**SUBJECT:**  
Transfer Case Shifter  
Noise

**NO:** 21-09-98  
**GROUP:** Transmission  
**DATE:** Jul. 31, 1998

**THIS BULLETIN SUPERSEDES TECHNICAL SERVICE BULLETIN NUMBER 21-02-97 REV. A, DATED, JULY 11, 1997, WHICH SHOULD BE REMOVED FROM YOUR FILE AND NOTE IN THE 1997 BOUND TECHNICAL SERVICE BULLETIN MANUAL, PUBLICATION NUMBER 81-699-98004. THE BULLETIN ADDS MODELS AND ADDITIONAL PARTS. THE CHANGES ARE HIGHLIGHTED WITH \*\*ASTERISKS\*\*.**

**FIGURE 1**

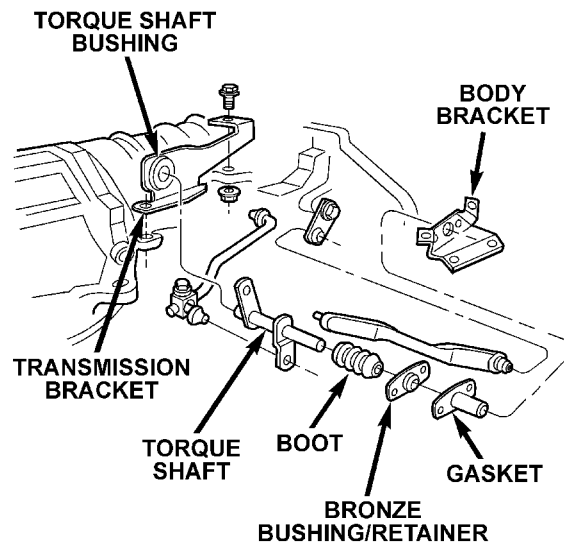
2. Remove the torque shaft by prying the shaft out of the green torque shaft bushing in the transmission bracket. (Refer to Figure 1) Install new bushings on the torque shaft for XJ and TJ.
3. Remove the bronze bushing/retainer and rubber gasket from the body bracket.
4. Remove the green torque shaft bushing from the transmission bracket and install the new bushing supplied in the kit.

4. Insert the new gasket into the body bracket.
5. Install the bronze bushing/retainer and tightening the screws to 5 Nm (45 in. lbs.).

**\*\*NOTE: TJ AND XJ MODELS USE THE ORIGINAL TORQUE SHAFT WITH THE NEW PARTS SUPPLIED IN THE XJ/TJ KIT. ZJ/ZG REQUIRE REPLACEMENT OF THE TORQUE SHAFT WHICH IS SUPPLIED IN THE ZJ/ZG KIT.\*\***

6. Slide the boot on to the torque shaft and apply multipurpose grease ( MOPAR p/n 04318063 or equivalent) to the area that the bronze bushing will contact.
7. Install the torque shaft and seat the boot on the bushing retainer flange.
8. Connect the transfer case shift linkage and adjust as necessary.
